FLOOR JOIST WALK THROUGH REPORT

Subdivision:	Example		
Builder / ATTN:	Example		
Plan Name / LogIn:	C06116494	JobID: C06116494	
Inspected By:	BobMyles	Inspection Date:	1/1/1901
Permit#/Municipality:	Example		
Address:	Example		
Construction Stage @ time of inspection:	FIRST,SECOND,ROOF CEILING,

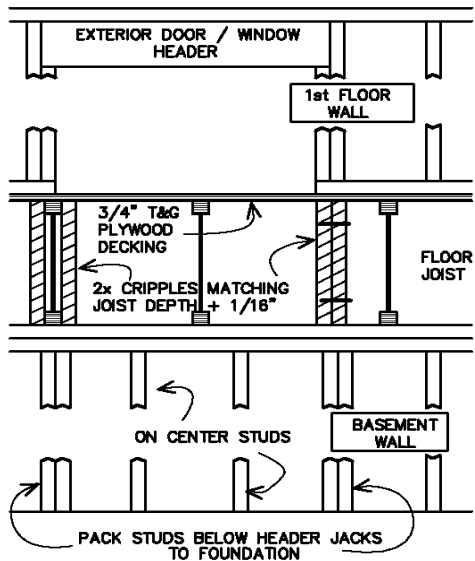
A	Ceiling joists are over-spanned or spanning wrong direction	Ceiling Joists in BR2 spanning left to right... not to plan, but walls carry the weight properly
	Roof improperly braced or bracing installed to non-bearing location (Header, non-stacking wall...)	
	Ceiling Beams not installed as specified on SPC plan	
	Joist layout not per SPC plan; Start location, Spacing, Shifts or Extras	
	Joist(s) cut or damaged	
	Bearing walls do not appear to be level	
	Wall locations do not correspond with SPC plan	
	Beam incorrectly located per SPC plan	
	Minimum bearing not provided for beam or joist(s)	
B	Beam, Girder or Point Load From Above (P.L.F.A.) not properly supported. See detail "E" on reverse.	Pack all PLFA's in Joist space area
C	Exterior door header jacks not supported in joist space below. Refer to detail "A" on reverse	Pack all exterior Door jacks in joists space
	Hanger(s) missing. Install per SPC plan detail

Wrong hanger(s) installed	
D	Hanger(s) not nailed correctly or completely	Add some nails to the hangers
	No glue used in hanger seats. Use glue in hangers per SPC plan detail	
	Incorrect material installed. (Beam, Depth or number of plies. Header, Girder, Joist or Rim Band)	
E	Blocking panels omitted or removed. Refer to detail "C" on reverse	Two blocking panels remove---- re-install
	Deadwood improperly installed or omitted. Refer to detail "B" on reverse	
	Decking not properly installed with glue and nails or screws	
	Confirm that deck attachment conforms to pertinent building code

Job Status:	PLBG,HVAC,ELEC,	
Additional Comments:	Good Framing Overall, Pack some Point loads & exterior door headers, add some blocking panels and add som nails to hangers for perfect installation.	Superintendant Signature and Printed Name
		<i>Example Signature</i>
		Example Super
